Town Creek Restoration Project – Option B Final Monitoring Report/Closeout Report

DMS Project ID Number – 95026; NC DEQ Contract No. 003990

Subject: Task 9: Annual Final Monitoring Report/Closeout Report – Monitoring Year 5 & Response to Comments
Town Creek Restoration Project – Option B
Yadkin River Basin – CU# 03040105 – Stanly County, NC
NCDMS Project ID No. 95026; NCDEQ Contract No. 003990

Fig 2A

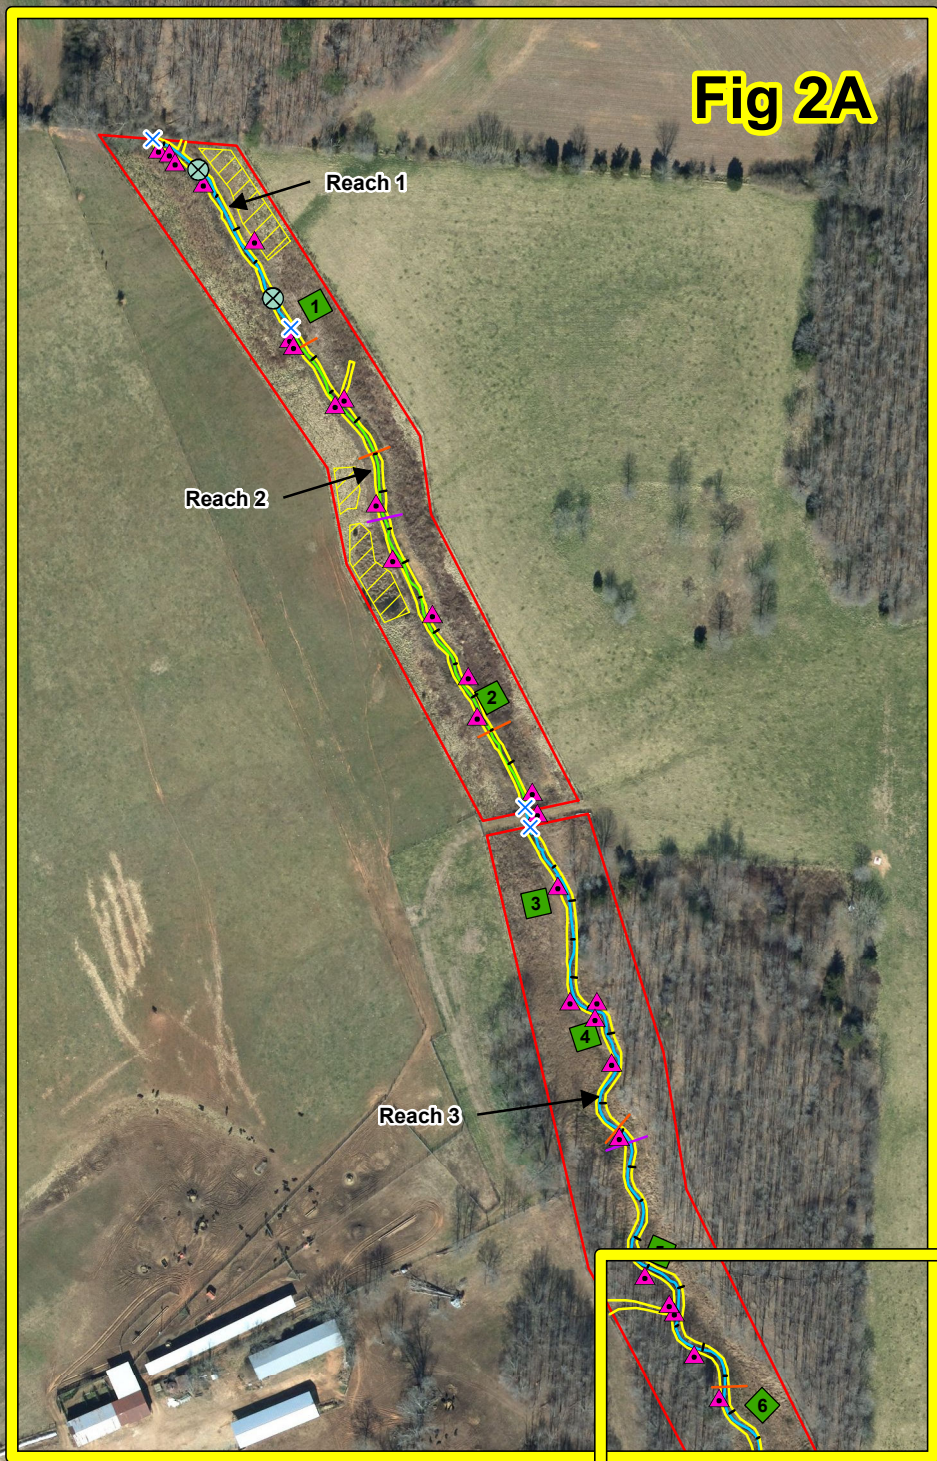
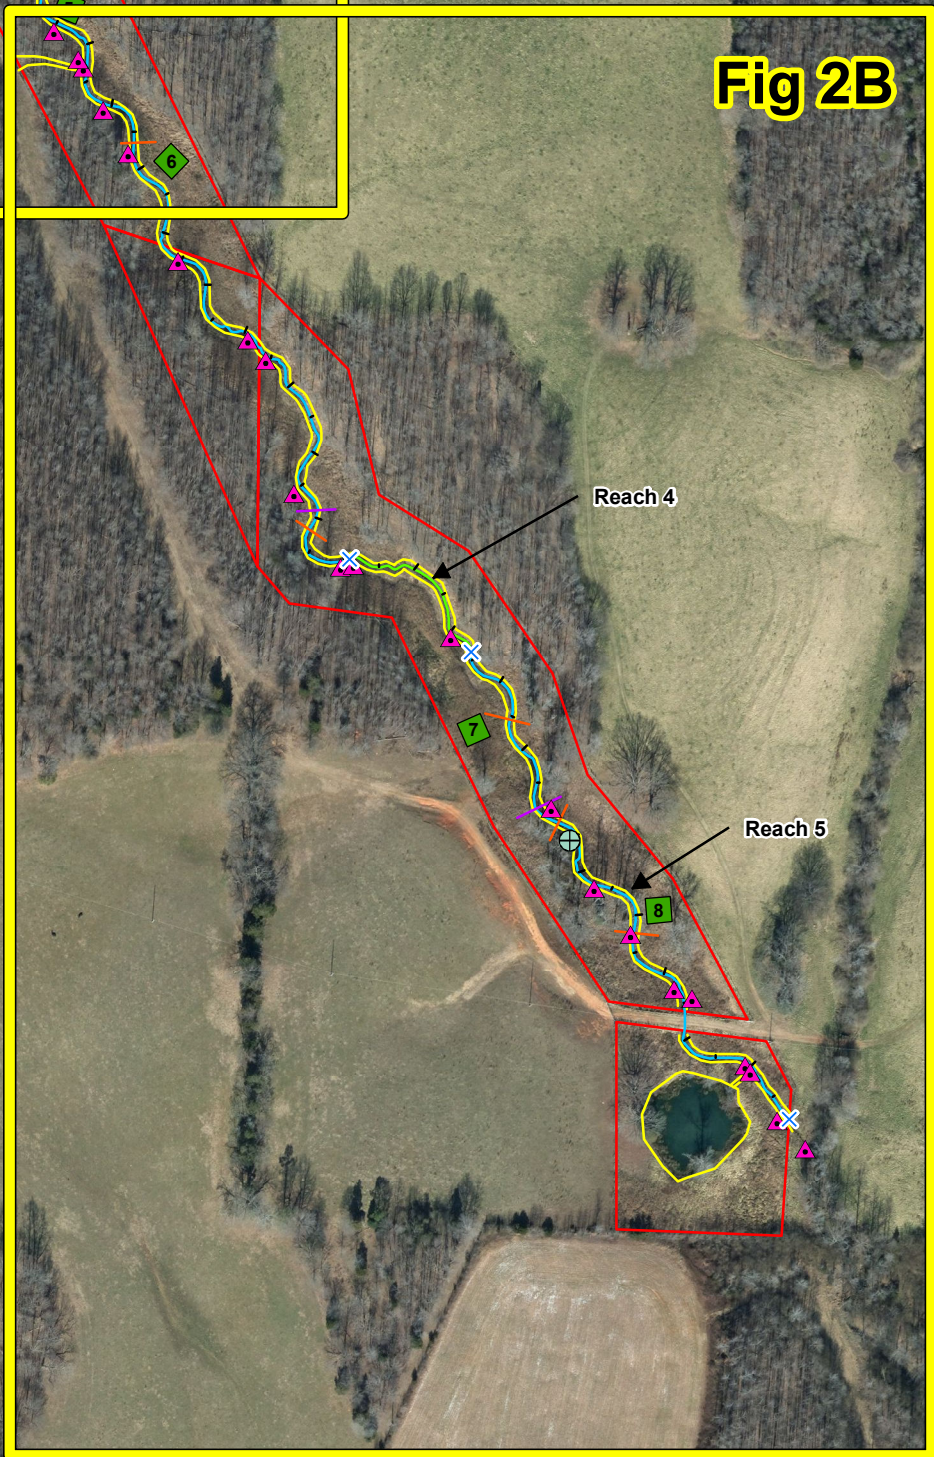
Comment - Please submit the features that characterize the cross sections, crest gauge, and in-stream pressure transducers in Figs. 2A-2B.

Response – Shapefiles that characterize the cross sections, crest gauge, and flow gauges have been added per DMS request.

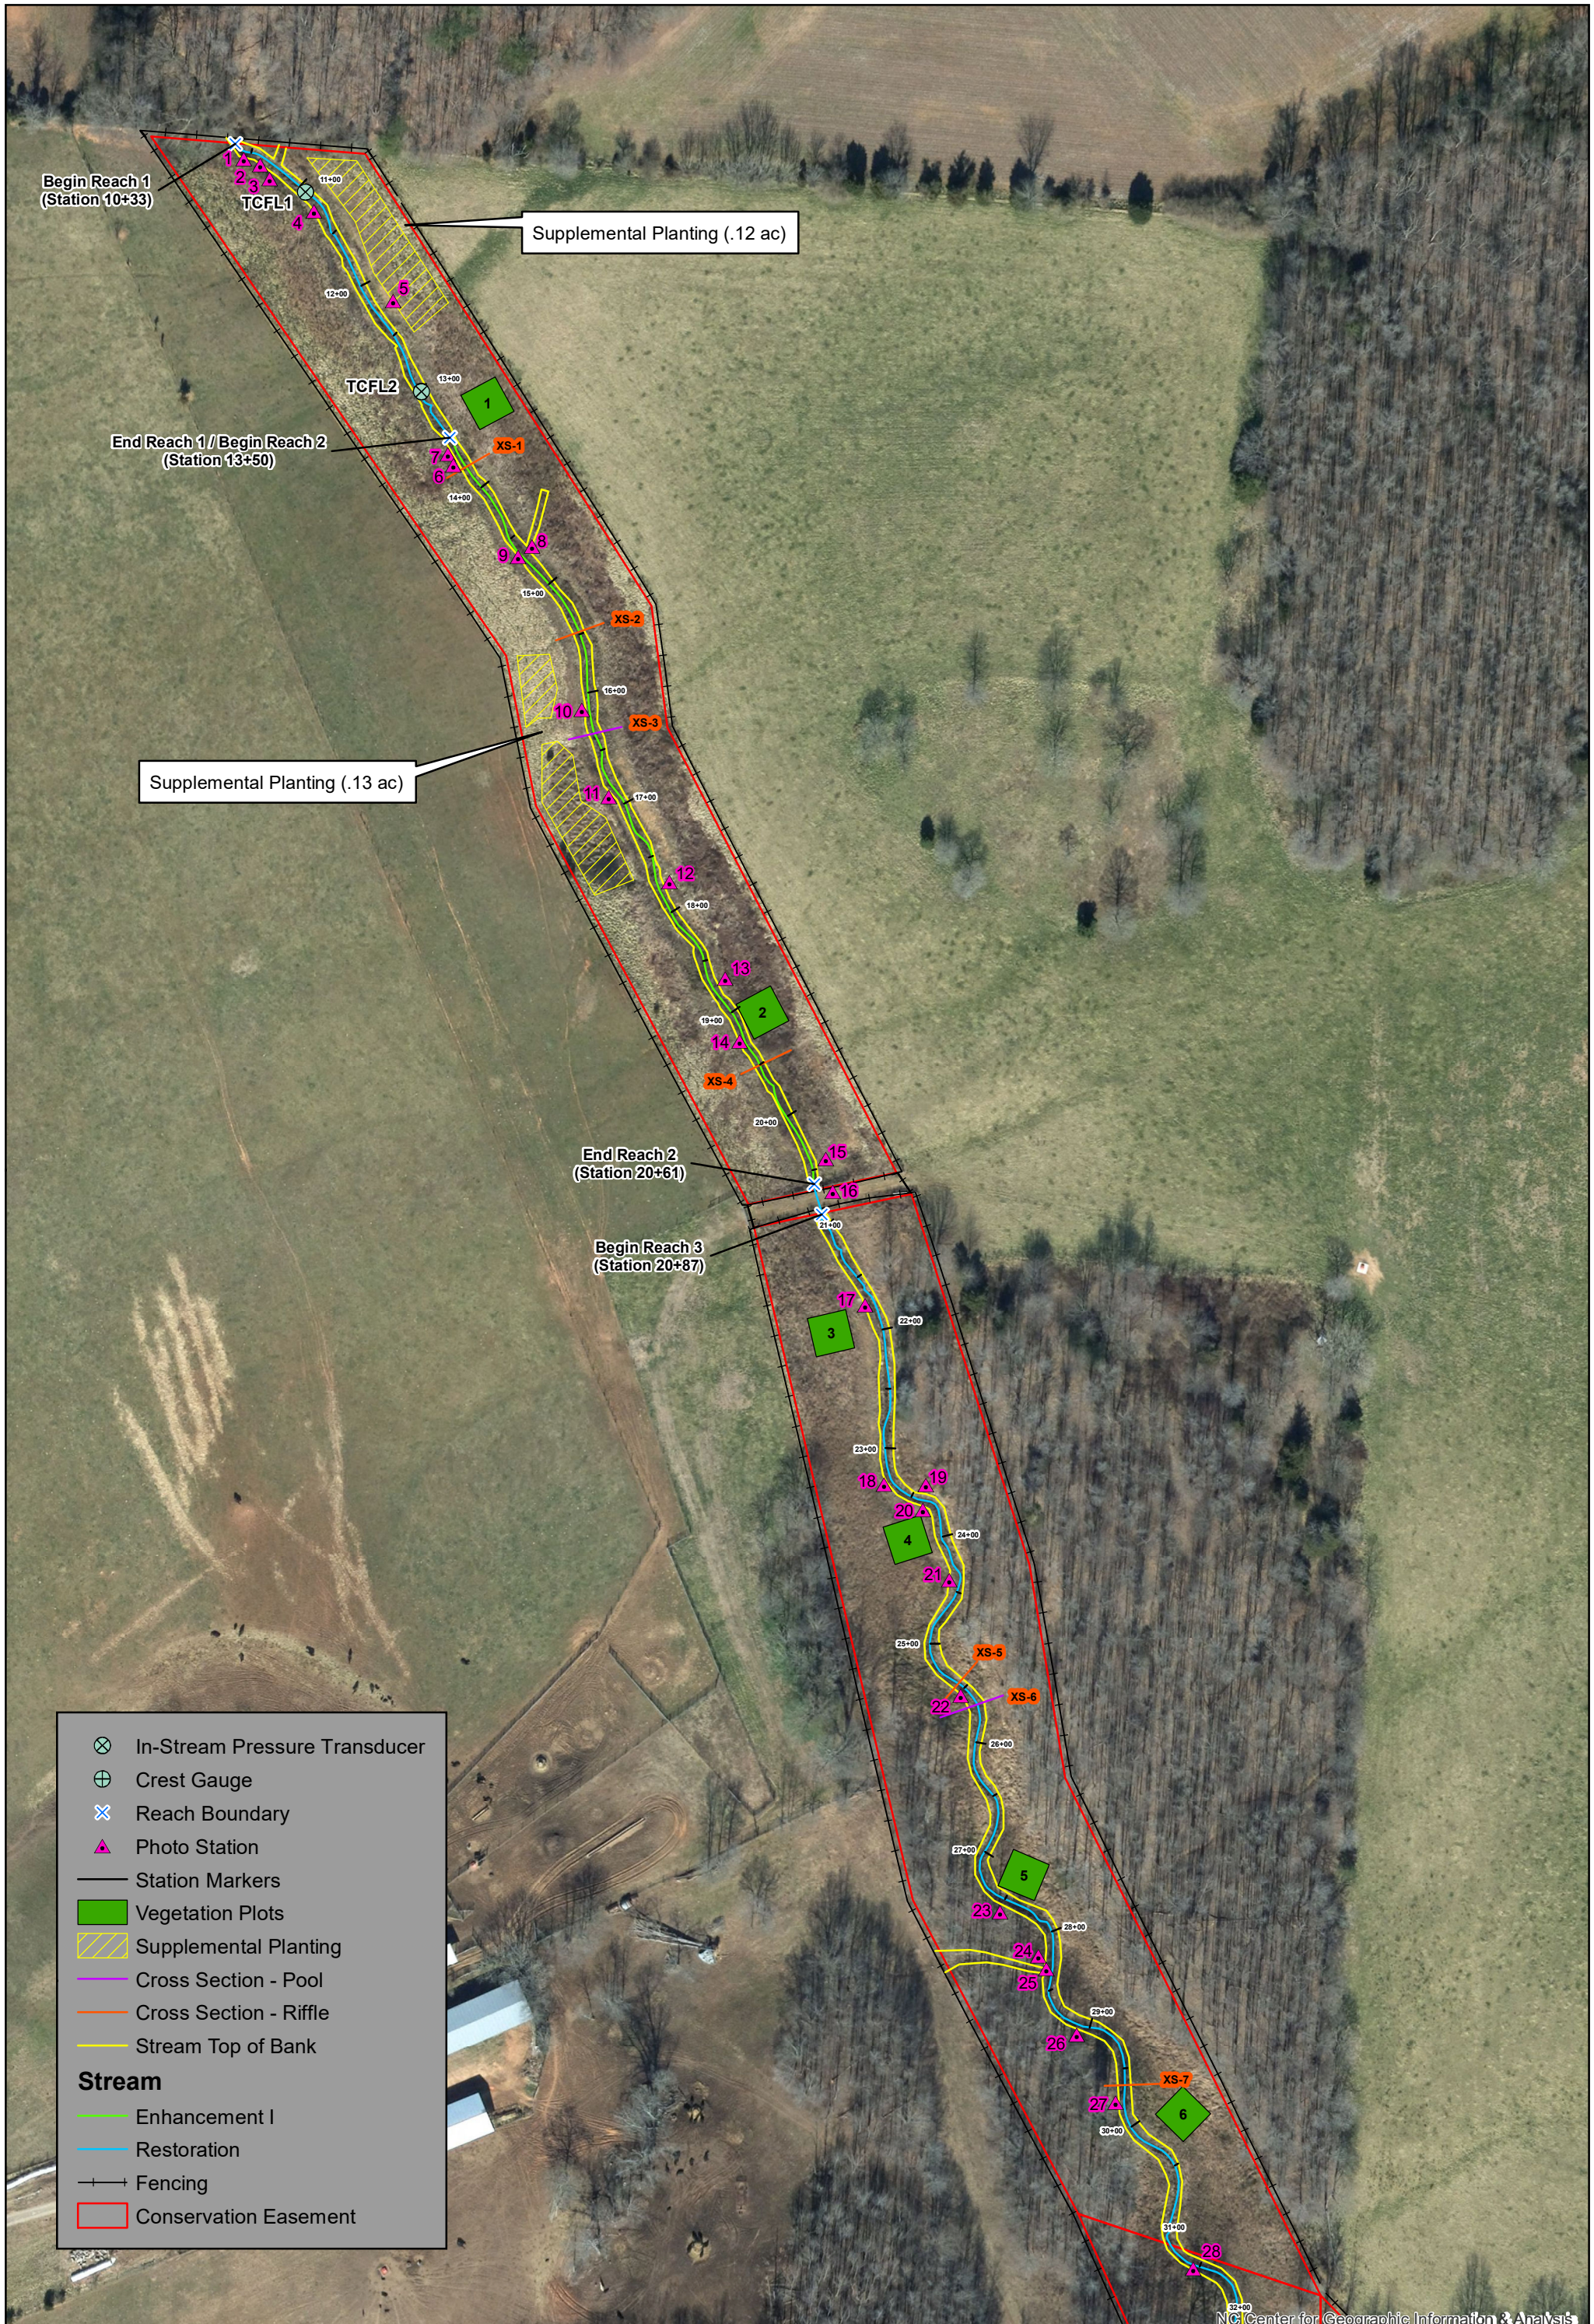
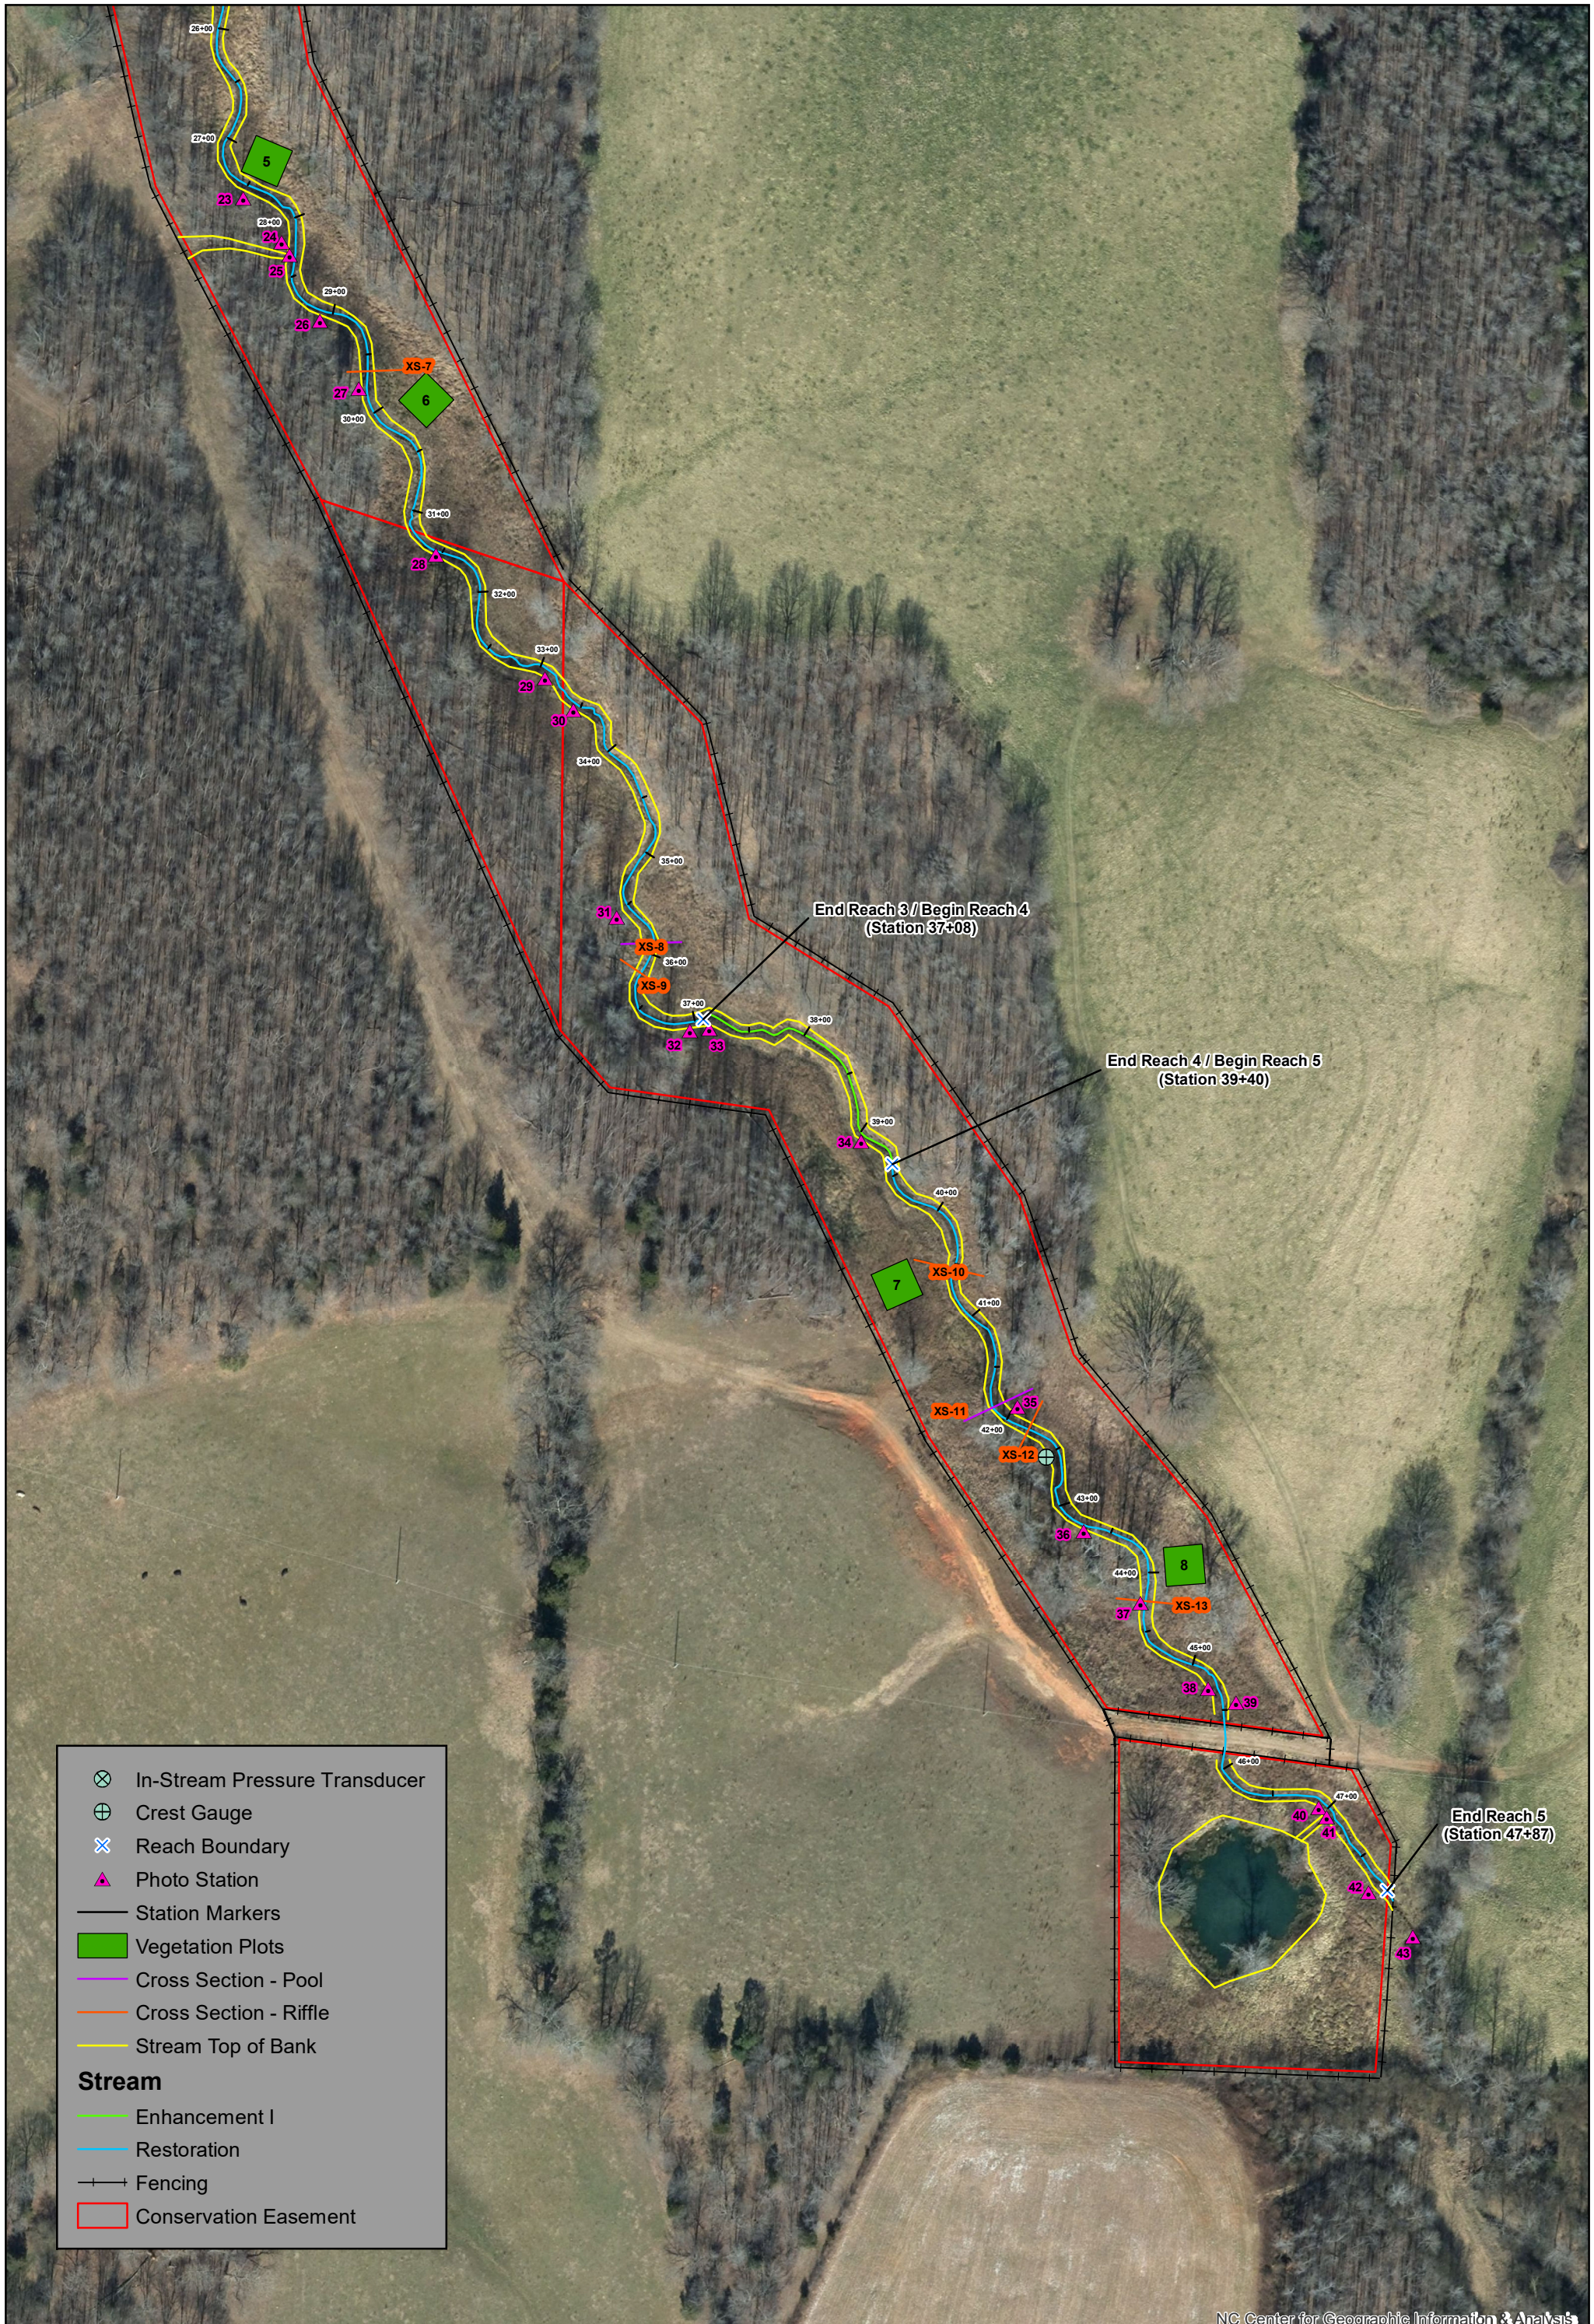
Comment - Supplemental planting is noted on the CCPVs but not in Table 2, Project Activities. Please update the table accordingly. In addition, please include the 2020 invasive treatment in the table (not necessary to include in the maps since you indicated the occurrences were below the mapping threshold).

Comment - There are 75 photo points contained in the digital submission, but only 43 points in the CCPV, which has been the case since the as-built. The unique ID's included in the submitted shapefile also do not appear to match the CCPV. It looks like the submitted shapefile may contain points for cross section and veg photos as well. Please update this shapefile and resubmit so that the spatial data reflects only the photo stations in the CCPV with matching unique ID's.

Response – Revisions have been made per DMS request.

Response – The Shapefile including the unique ID's and the correct amount of photo points have been added to the digital submission file as requested.
